AMENDMENTS TO THE DRAWINGS

REMARKS/ARGUMENTS

This case has been carefully reviewed and analyzed in view of the Office Action dated 2 November 2005. Responsive to that Office Action, Claims 1 and 2 have now been amended, and Claims 3-5 newly-inserted for further prosecution. It is believed that with such amendment and insertion of Claims, there is a further clarification of their recitations.

FIG. 2

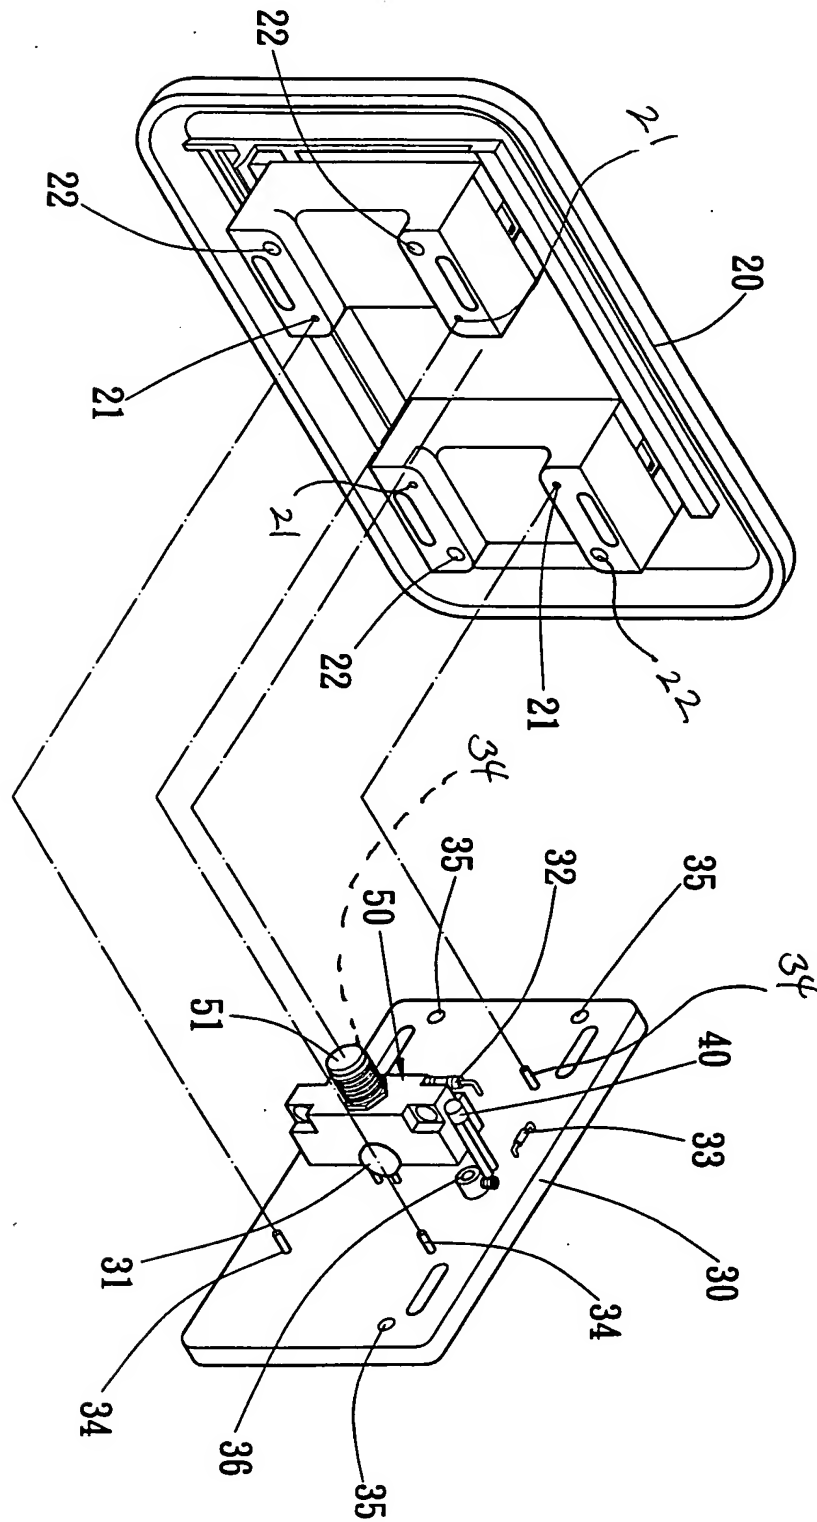
Certain of the Drawings as originally filed are hereby amended to more clearly and correctly indicate the various disclosed elements by their corresponding reference characters. Such clearer notation of the reference characters removes the apparent confusion encountered by the Examiner in correlating, for instance, the circuit diagram of Figs. 3 and 4 with the structural views shown in Figs. 2 and 5.

The corrections to the Drawings specifically include, among other things, notation of the conductive portions of the circuit schematic diagrams illustrated in Figs. 3-4 which correspond to the plurality of insertion holes 21 and insertion rods 34 represented in Figs. 2 and 5. The Drawings corrections also include notation of the reference characters 60, 60' appropriately at the input terminals labeled “AC in” in the circuit schematics of Figs. 3-4, making clear that these input terminals were properly labeled (as the Examiner had surmised that these terminals should have been labeled “AC out”). In addition, the output terminal incorrectly noted by the reference character “36” is now corrected to be noted by the correct reference character “22.”
